WBS-680 Audio Board Auxiliary Input Internal Modification

(Raw Board No. 750608 Rev A)

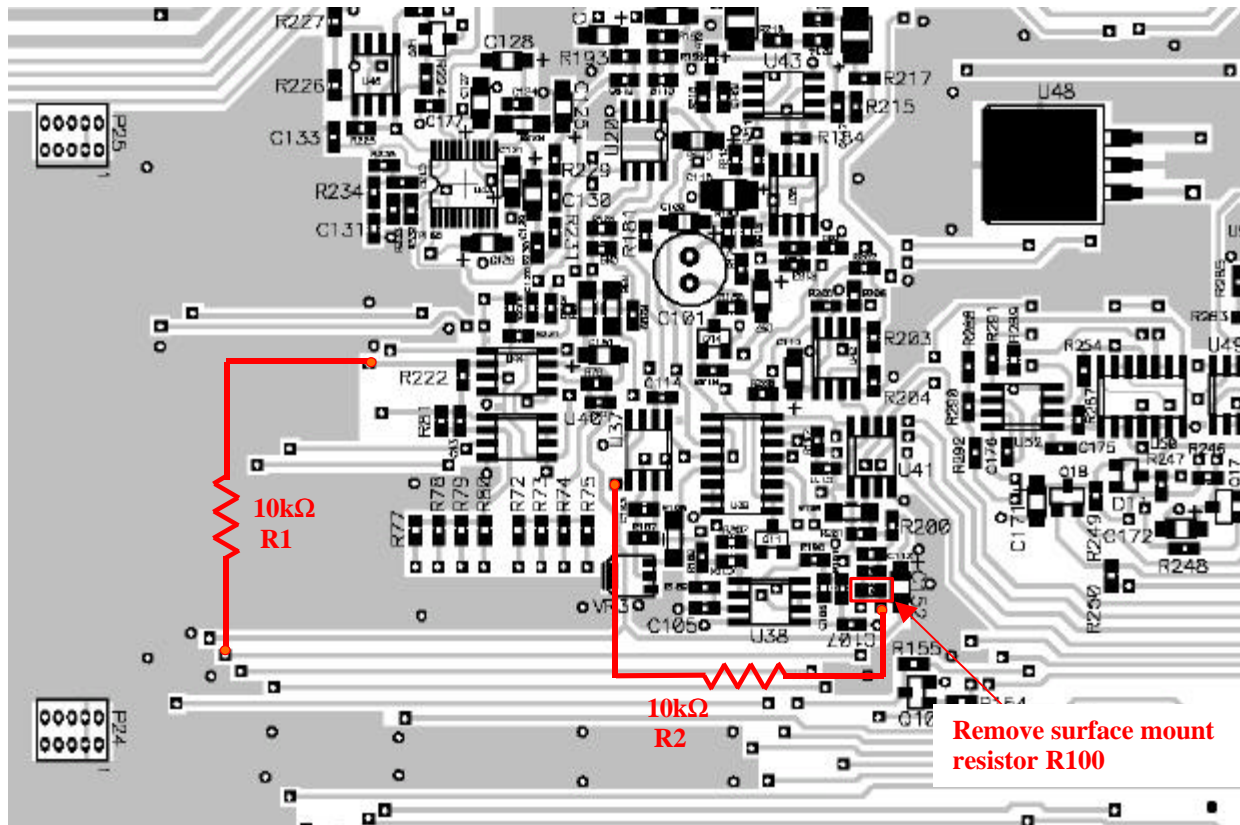
PURPOSE: This modification “disconnects” auxiliary input audio from being placed onto any wired intercom system connected to the unit. The auxiliary input audio is heard locally, within the base station and its’ beltpacks, but not sent to the wired interface. This modification does not affect auxiliary audio out, thus auxiliary out will contain I/C B audio, which is composed of all locally generated audio (base and beltpacks) and all wired intercom audio.

CONNECTION DETAILS: Connect R1 from the auxiliary trace to pin 2 of U44 via the trace extending from U44. Remove surface mount resistor R100 (10k Ω). Place resistor R2 from the via just below the removed resistor to pin 5 of U37. Resistors R1 and R2 are 10k Ω and 1/8 Watt. Ensure the resistor leads cannot short to ground or another trace. Small diameter heat shrink may be used over the leads to insulate them.
